EXECUTIVE ORDER D-133-15  
Relating to Exemptions under Section 27156  
of the Vehicle Code

REDLINE, INC., A SUBSIDIARY OF IMPAC  
REDLINE CARBURETOR CONVERSION KITS #K8256, #K8257 AND #K8201  
USING ONE (1) WEBER MODEL 32/36 DGAV 33B1

EVALUATION OF THE REDLINE CARBURETOR CONVERSION KITS  
NO. K8256, NO. K8257 AND NO. K8201 USING ONE (1) 32/36  
DGAV 33B1 WEBER CARBURETOR FOR EXEMPTION FROM THE  
PROHIBITIONS OF VEHICLE CODE SECTION 27156 IN ACCORDANCE  
WITH SECTION 2222, TITLE 13 OF THE  
CALIFORNIA ADMINISTRATIVE CODE

GRAPH A-6.1

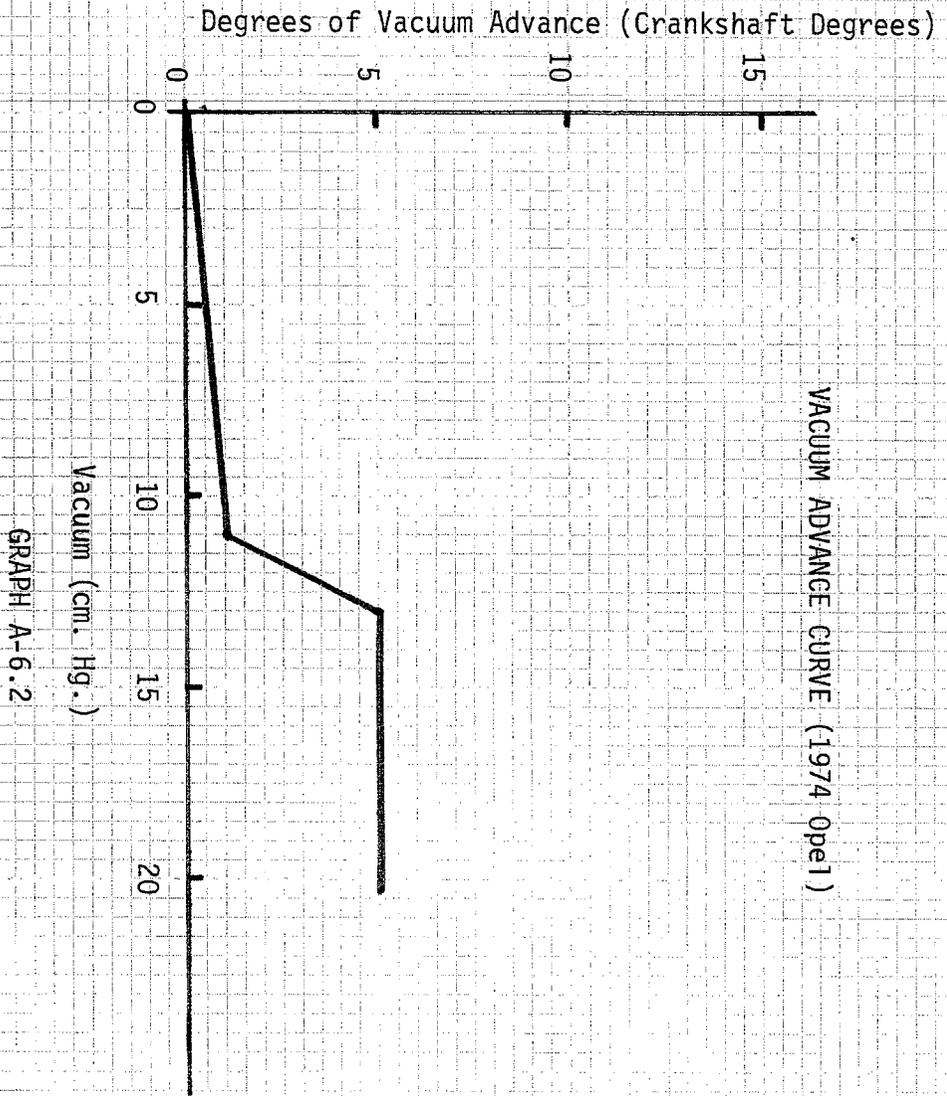
Graph A-6.1 shows the dry flow bench depression of the OEM Solex carburetor for a 1974 Opel (Solex) and the Weber 32/36 DGAV 33BI (Weber) versus the throttle opening in degrees. Graph A-6.2 shows the vacuum signal strength versus spark advance in crankshaft degrees. From this it can be seen that the only area of interest on Graph A-6.3 is between 11.0 and 13.0 cm. Hg. Graph A-6.3 shows that the Weber signal is stronger than the Solex. At small throttle openings the Weber will provide full vacuum advance approximately 3 throttle plate degrees sooner than the Solex will provide full vacuum advance. At small throttle openings, which correspond to light loads and low vehicle speeds, the staff concludes that a slight change vacuum advance versus throttle angle will not have a significant effect on emissions. At large throttle openings the Weber will begin reducing vacuum advance approximately 12 throttle plate degrees later than the Solex will begin reducing vacuum advance. Therefore the Weber will provide for slightly more spark advance at larger throttle openings. At large throttle openings, which correspond to heavy loads and high engine and vehicle speeds the distributors' centrifugal advance mechanism is providing approximately 30° of spark advance. The Weber will provide for 5° additional spark advance which amounts to a 16% change in total spark advance. Based on previous evaluations

GRAPH A-6.5

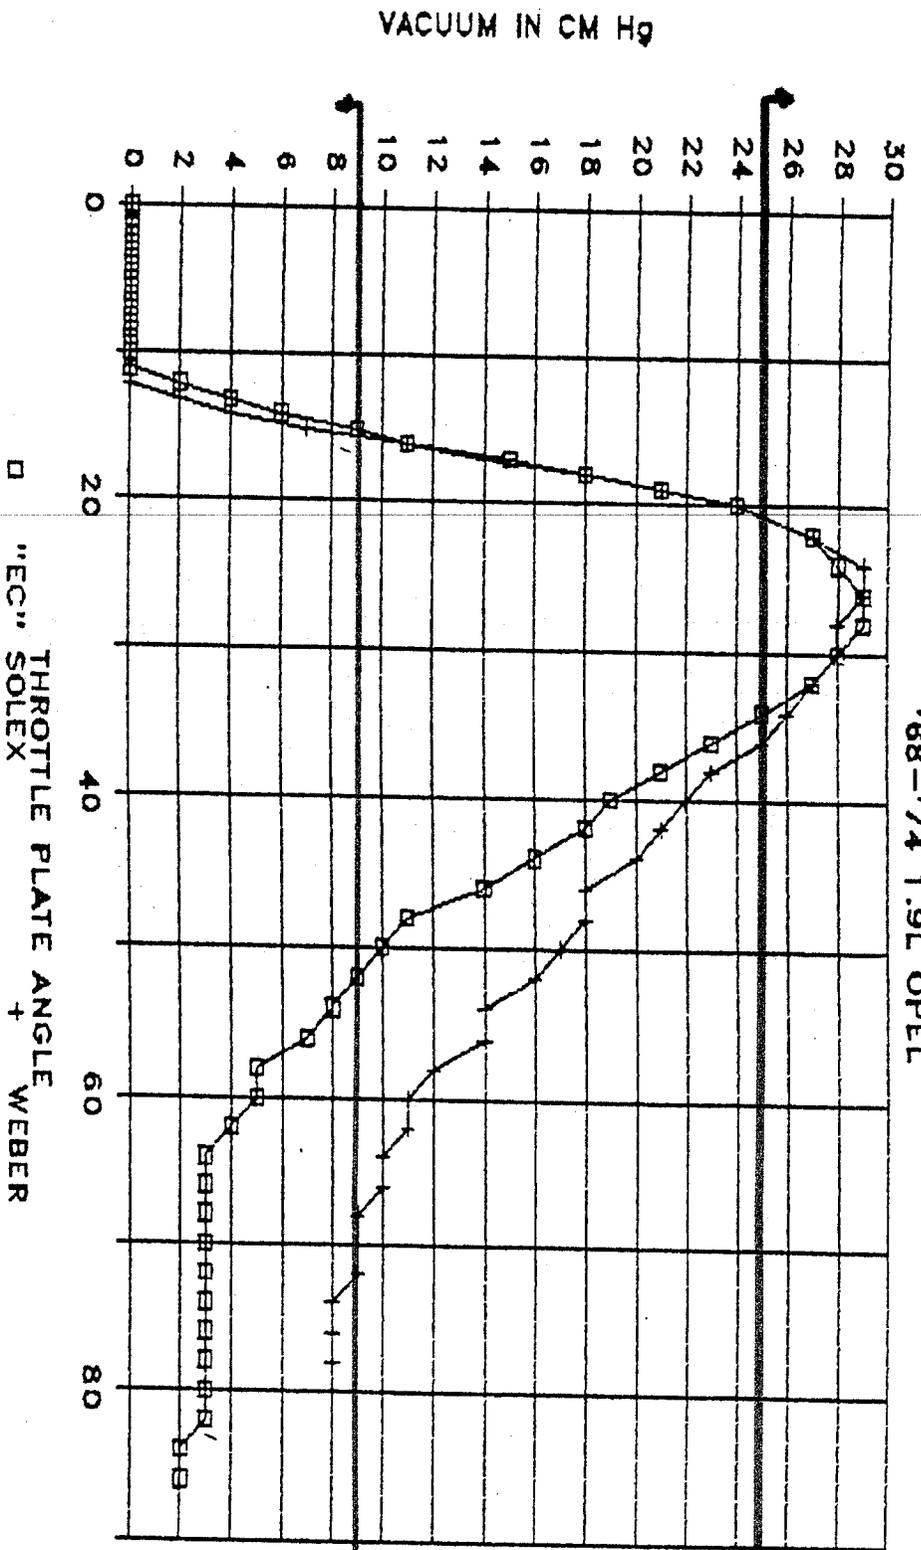
Graph A-6.4 shows the vacuum signal strength versus EGR flow. From this it can be seen that the only area of interest on Graph A-6.5 is between 9.0 and 25.0 cm. Hg. At small throttle openings the Weber signal matches the Solex. At large throttle openings the Weber signal is stronger than the Solex which will keep the EGR flow on longer than the Solex. This should theoretically slightly reduce emissions. Any differences in the two vacuum signal strength curves outside of the area of interest are irrelevant. Also submitted was a comparison of the automatic choke operation between the two carburetors which shows that they function nearly the same.

At 25.0 cm. Hg. and above the EGR valve approaches the low flow position.

Between 9.0 and 25.0 cm. Hg. the EGR valve is in the max flow position.

At 9.0 cm. Hg. and below the EGR valve is in the no flow position.

GRAPH A-6.6

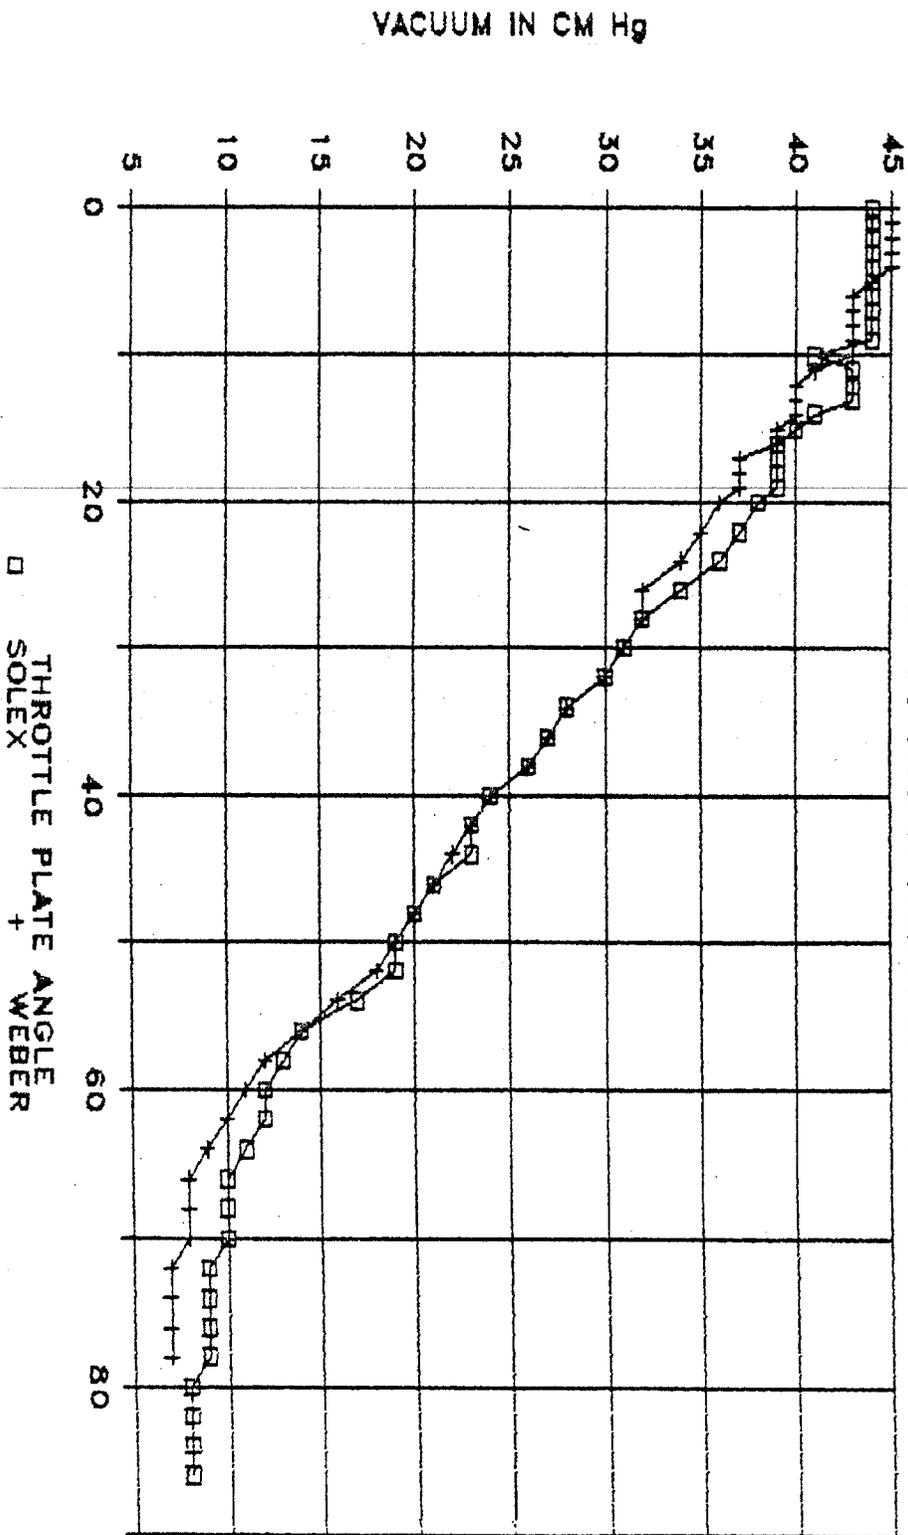
Graph A-6.6 shows the dry flow bench depression of the OEM Solex carburetor for a 1974 Audi (Solex) and the Weber 32/36 DGAV 33B1 (Weber) versus the throttle opening in degrees. Graph A-6.7 shows the vacuum signal strength versus spark advance in crankshaft degrees. From this it can be seen that the only area of interest on Graph A-6.8 is between 10.0 and 15.0 cm. Hg. At small throttle openings the Weber will provide full vacuum advance approximately 3 throttle plate degrees later than the Solex will provide full vacuum advance. At small throttle openings, which correspond to light loads and low vehicle speeds, the staff concludes that a slight change vacuum advance versus throttle angle will not have a significant effect on emissions. At large throttle openings the Weber will begin reducing vacuum advance at the same throttle opening as the Solex, but reduces the vacuum advance at a slightly faster rate. This will cause the spark timing to be slightly retarded ( $5^{\circ}$ ) with respect to stock. Since the distributors' centrifugal advance mechanism is providing  $30^{\circ}$  of spark advance, at these throttle openings, the  $5^{\circ}$  change amounts to a 16% change in total spark advance. Based on previous evaluation of other Weber carburetor conversions that modify the vacuum advance versus throttle angle curve in a similar manner and showed no increase in exhaust emissions when tested on a back-to-back CVS-75 (stock vs. modified) basis, the staff concludes that the change in spark advance due to the Weber carburetor will not significantly effect emissions from the Audi vehicles during typical urban driving conditions. Any difference in the two vacuum signal strength curves outside of the area of interest are irrelevant. Some Audi vehicles also utilize a vacuum retard system. This system receives its signal from a manifold vacuum source and, therefore, is not affected by the Weber carburetor.

GRAPH A-6.9

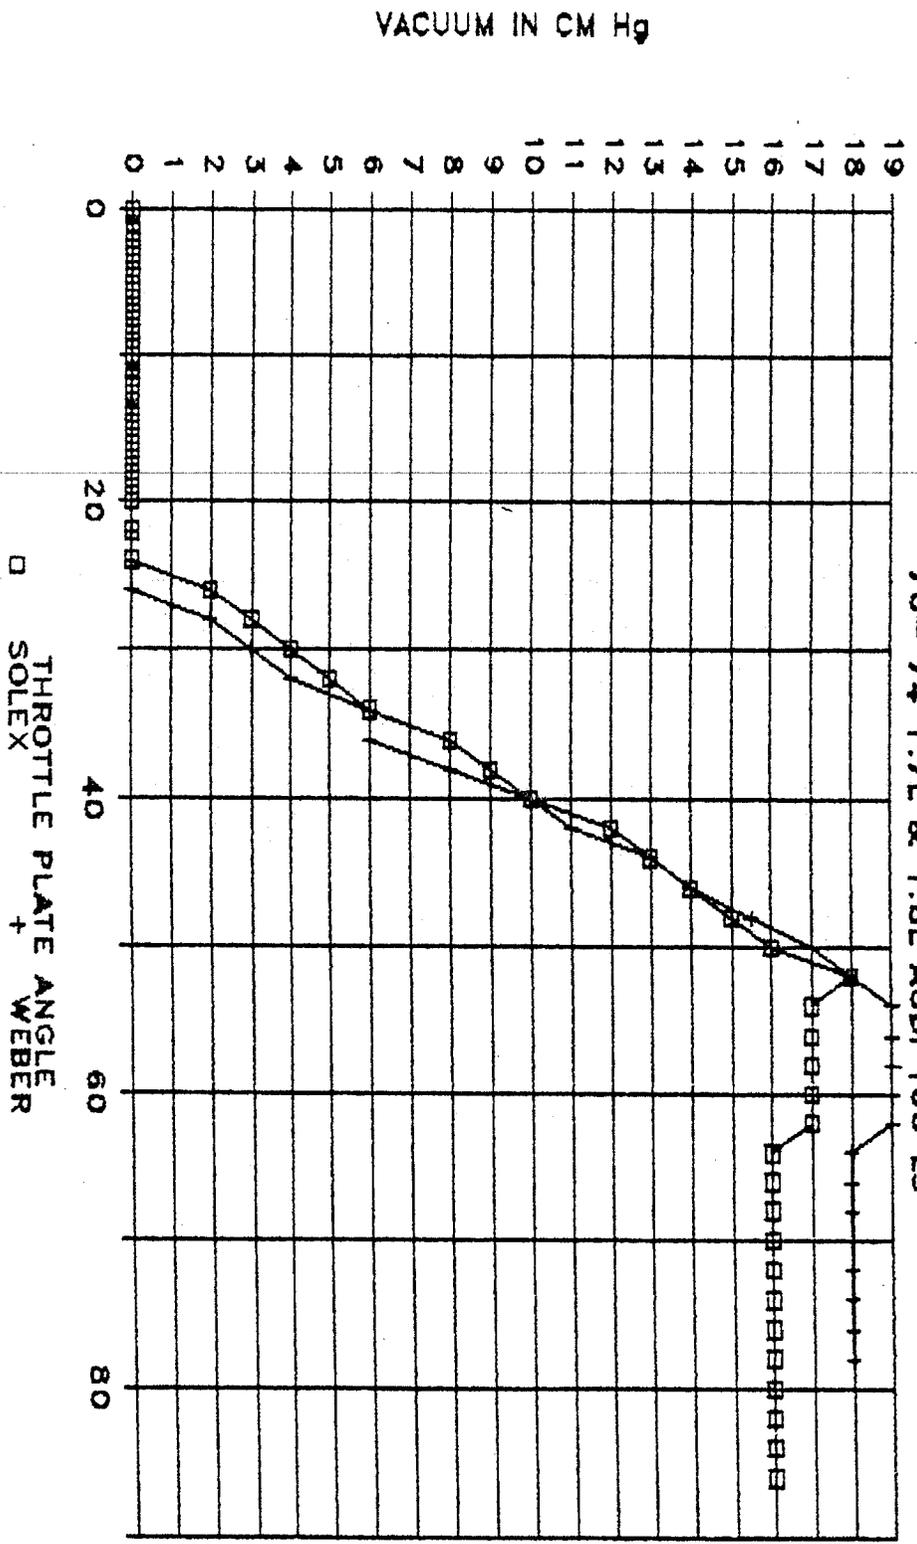
Graph A-6.9 shows the venturi vacuum signal of the Solex and the Weber. From this it can be seen that both carburetors produce nearly the same signal which should cause the EGR to function the same with the Weber installed.
